Category F (01)	Applicable Model/s 1999 Miata	Subject HARD TO REFUEL	Bulletin No. 007/99
			Issued 04/02/99
			Revised

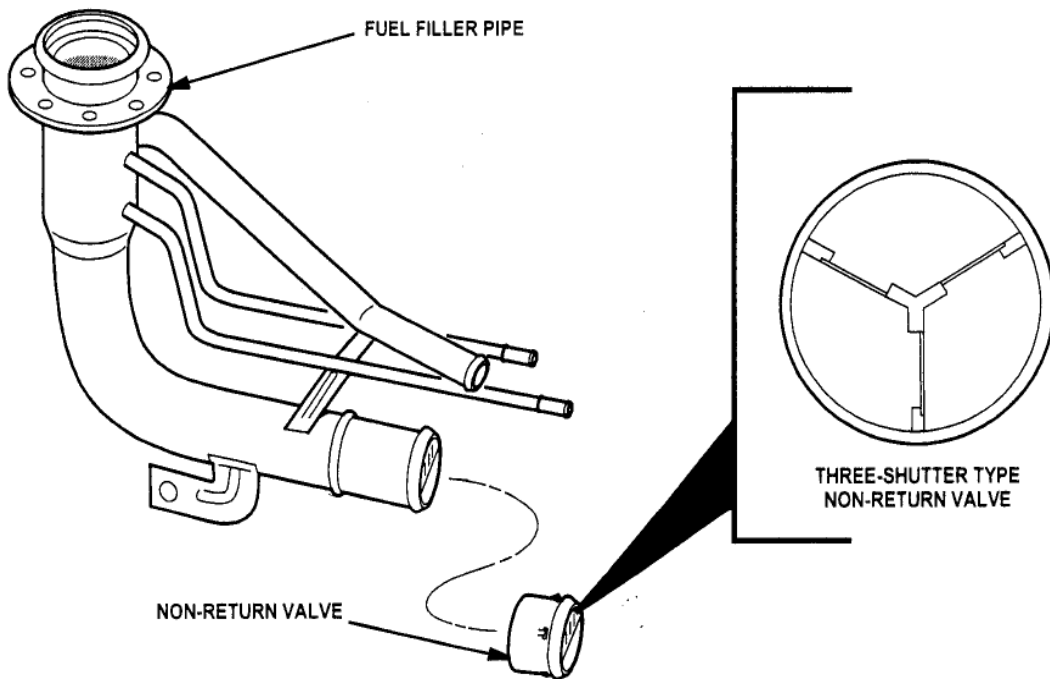
Excessive amount of time is required when refueling the vehicle due to pump nozzle repeatedly shutting off. This may be caused by the non-return valve (one-shutter type) becoming stuck in the closed position. A modified (three-shutter type) non-return valve is now available to resolve this concern.

1. Verify customer concern.
2. Replace the non-return valve with the modified part according to the Workshop Manual (section 01-14).

Part Number	Description	Qty.	Notes
GE4T 42 270	Non-return valve	1	---
